SOUTHERN REGIONAL PLANNING PANEL

JRPP No	2019STH001 DA
DA Number	DA-2018/1638
Local Government Area	Wollongong City
Proposed Development	Mixed use development – fourteen (14) storey building comprising of one hundred and two (102) residential units and eight (8) commercial tenancies over two (2) levels of basement parking
Street Address	71-77 Kembla Street, WOLLONGONG Lot 502 DP 845275
Applicant/Owner	Applicant – ADM Architects; Owner – City Investments Pty Ltd
Number of Submissions	Initial notification period - six (6) submissions in objection to the proposal Second notification period – 45 submissions in objection to the proposal
Regional Development Criteria	Clause 3, Schedule 4A of the Environmental Planning & Assessment Act 1979; general development over \$30 million. The applicant's CIV estimate for the project is \$43,270,000.
List of All Relevant s4.15(1)(a) Matters	<ul style="list-style-type: none"> ▪ List all of the relevant environmental planning instruments: s4.15(1)(a)(i) – <p><u>State Environmental Planning Policies (SEPPs):</u></p> <ul style="list-style-type: none"> ▪ SEPP No. 65 – Design Quality of Residential Apartment Development ▪ SEPP (Coastal Management) 2018

Figure 3 – IRT Parkside building – provided by TCG Planning

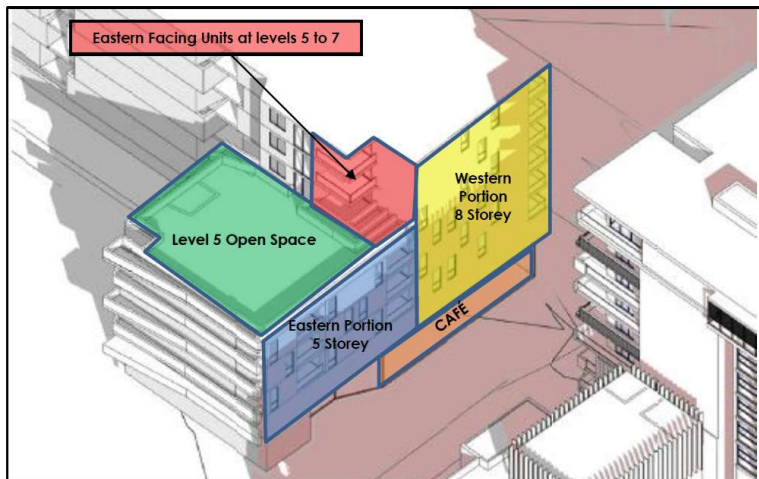
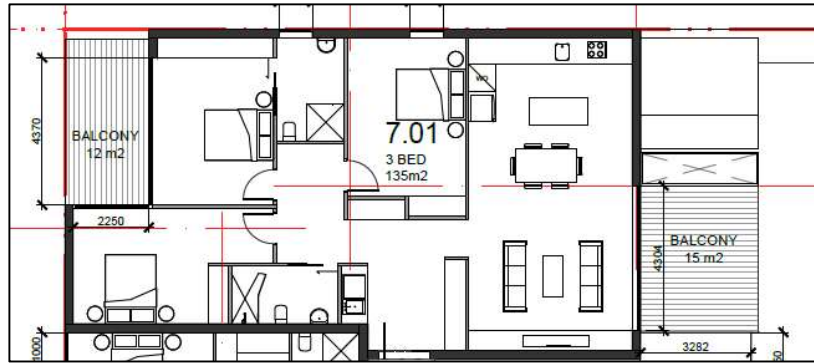
As illustrated above, the 'Parkside' building comprises two linked elements being an 8 storey west-facing block closest to the intersection of Stewart and Kembla Streets. This section is occupied by residential units on Levels 2-7 generally oriented to the east/west and south; and a ground floor café along the Stewart Street frontage. The second portion comprises a 5 storey north-facing block with frontage to Stewart Street – this is occupied by residential units at Levels 2-4 oriented to the north or south. There is also a communal open space located at Level 5 in this eastern section of the building.

The shadowing impacts of the development as originally conceived can be summarised as follows:-

- The main seating area of the ground level café will receive 3 hours of sunlight in mid-Winter (from 12pm onwards).
- The Level 5 communal open space will receive 3 hours of sunlight in mid-Winter (9am- 12pm).
- The primary living room windows and balconies of the units in the 8 storey section of the building will receive 3 hours of sunlight, due to their western orientation.
- There are three (3) east-facing units at Levels 5-7 of the building; these are highlighted pink on Figure 3. The floor plan and window placement of these units varies slightly but is generally as follows:

As per the above floor plan, these units have east-facing balconies and living room windows oriented over the L5 communal open space. Bedroom windows are generally located on the northern façade of the building (except one narrow secondary living room window at Level 5) and there are balconies and windows on the western end of these units. These units receive sunlight between 9am and approximately 10.30am and then from around 12pm onwards. It is noted that whilst afternoon sun to the eastern balcony is impacted by the proposed development, the 'Parkside' building itself overshadows such spaces in the afternoon period. At this time the west-facing windows and balconies will receive sunlight.

- Five (5) of the six (6) north-facing units within the lower, eastern portion of the building (highlighted blue in Figure 3) will not receive the required 3 hours of sunlight on June 21. Specifically, on L4 in this portion of the building, the majority of this level will be clear of shadow at 9am, with the living room and balcony of the eastern unit receiving sunlight through until approx. 11.30am. The balcony and primary living room window of the western unit will receive sunlight between 9am and 10.30am and will again receive sunlight between 1.30pm and 3pm. The living room and POS of the units at Level 4 in the eastern portion of the building will receive between approximately 2.5 to 3.0 hours of sunlight on June 21. On Level 3, the living room and POS of the eastern unit will receive sunlight between approximately 9.30am - 11.30am and between approximately 2.30pm - 3.00pm. The balcony and primary living room window of the western unit will receive sunlight between approximately 1.30pm - 3.00pm. Hence, the living room and POS of the units at Level 3 in the eastern portion of the building will receive between approximately 1.5 to 2.5 hours of sunlight on June 21. On Level 2, the living room and POS of the eastern unit will receive sunlight between approximately 2.30pm and 3.00pm. The balcony and primary living room window of the western unit will receive sunlight between approximately 1.30pm - 3.00pm. Hence, the living room and POS of the units at Level 2 in the eastern portion of the building will receive between approximately 0.5 to 1.5 hours of sunlight on June 21.

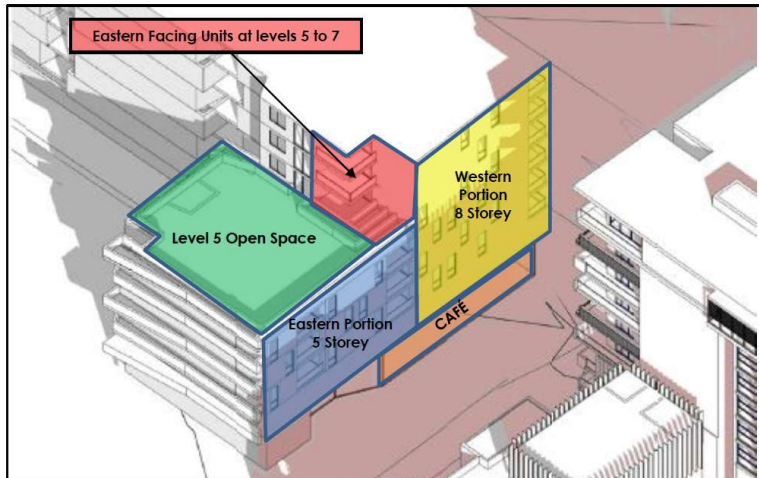
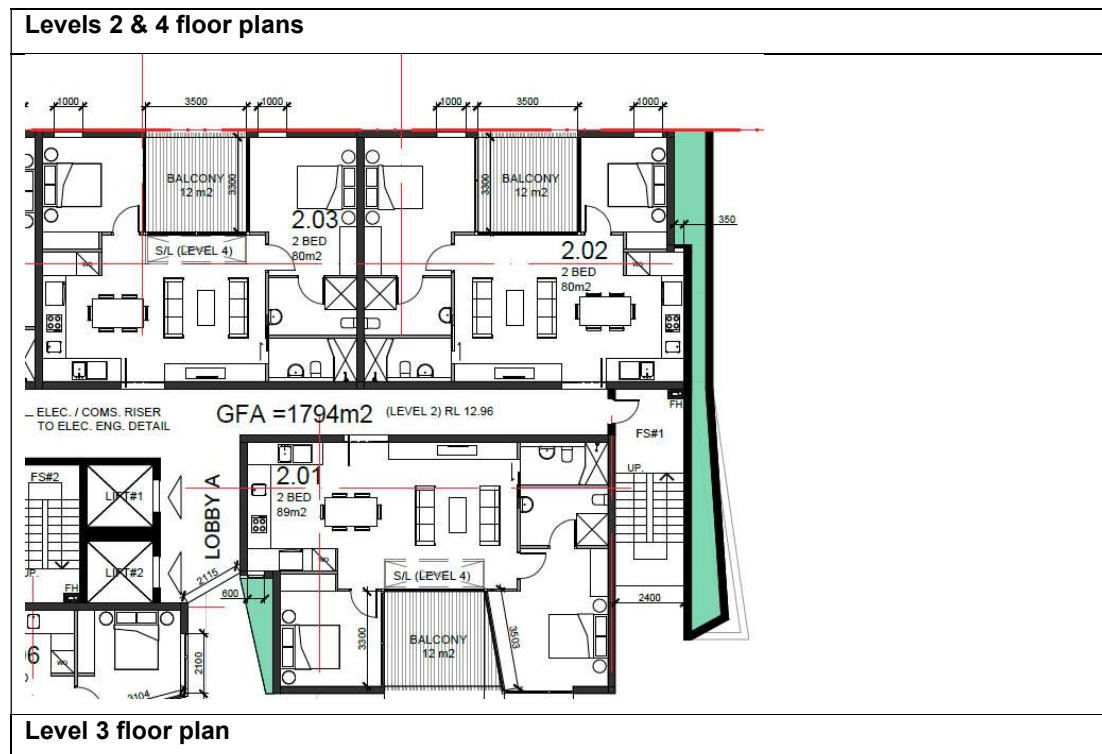
Figure 3 is reproduced again to aid the interpretation of the solar access discussion. The solar access diagrams indicate that there is no change to solar access to the ground floor café (orange), eastern facing units of Levels 5 to 7 (red), and marginal change to the western portion of the building (yellow), though this section of the building already received more than sufficient sunlight. The units that most benefit from the plan revisions in terms of improved solar access are those located within the blue section (eastern portion, 5 storey).

The plan revisions have reduced the extent of overshadowing impacts on the IRT Parkside building for parts of the day; this is summarised as follows:-

- At 9am – there is a slight reduction in overshadowing of the L4 eastern-most unit (blue); improved solar access to balconies L5 (blue); removal of L8 plant room has reduced shadow to L4 western units (yellow) all north-facing windows on this level will benefit from some improved solar access.

- At 9.30am - improved solar access to central balcony L4 (blue); removal of L8 plant room has reduced shadow to L5 western units (yellow) 2 central north-facing windows on this level will benefit from some improved solar access.

- At 10am - reduction in overshadowing unit L3 windows and central balcony (blue); improved solar access to 1 window L3 in yellow section.
- At 10.30am – improved solar access to both balconies on L3 (blue) and the windows of the north-facing units on that level (blue).

- At 11.00am – improved solar access to eastern balcony on L2 (blue) and the windows of the north-facing units on that level (blue).
- At 11.30am – improved solar access to eastern balcony on L2 (blue) – this balcony will receive full sun at 11.30am.

- 12pm – 1pm - no change.
- At 1.30pm - minor reduction in overshadowing of rooftop communal open space eastern portion of Parkside (green).
- At 2pm – no change.

- At 2.30pm – minor improvement to solar access to the L4 eastern-most unit (blue) north-facing window.
- At 3pm – no change.

Figure 4: Levels 2, 3 & 4 floor plans, eastern portion IRT Parkside building.

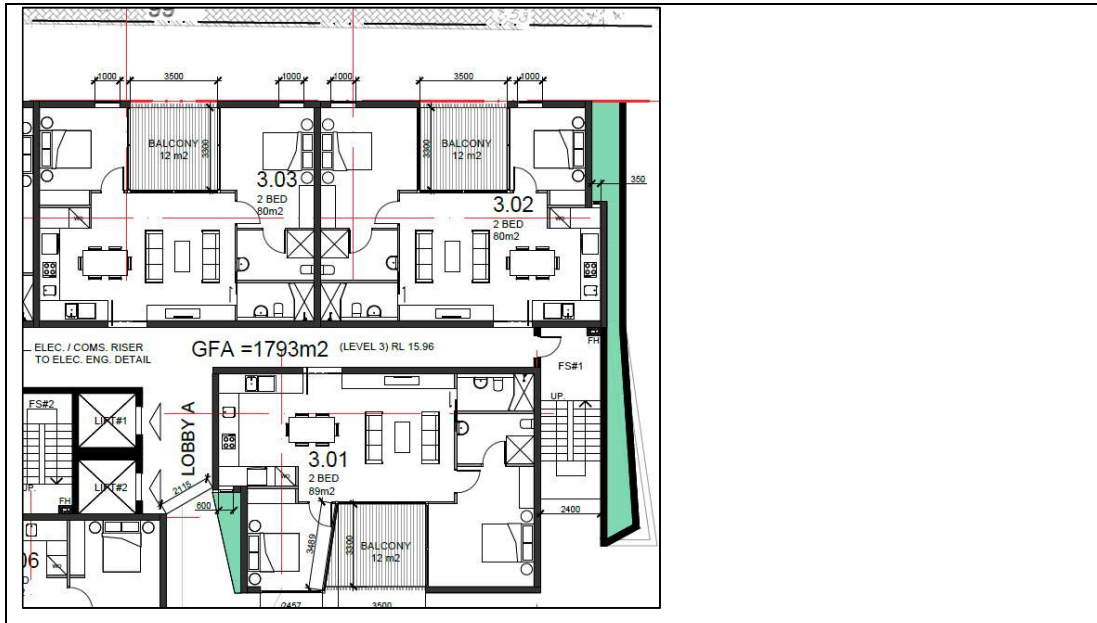
On the basis of the above analysis and that previously undertaken, five (5) of the six (6) north-facing units within the lower, eastern portion of the building (highlighted blue in Figure 3) will not receive the required 3 hours of sunlight on June 21. Each of the units within that portion of the building are discussed individually below:

The living room and POS of the units at Level 4 in the eastern portion of the building will receive between approximately 2.5 to 3.0 hours of sunlight on June 21.

The units on Level 2 of the IRT Parkside building are those most vulnerable to overshadowing given that they are at a lower elevation. Both of the units will receive less than 2 hours of sun on 21 June.

Hence, the living room and POS of the units at Level 2 in the eastern portion of the building will receive between approximately 0.5 to 1.5 hours of sunlight on June 21.
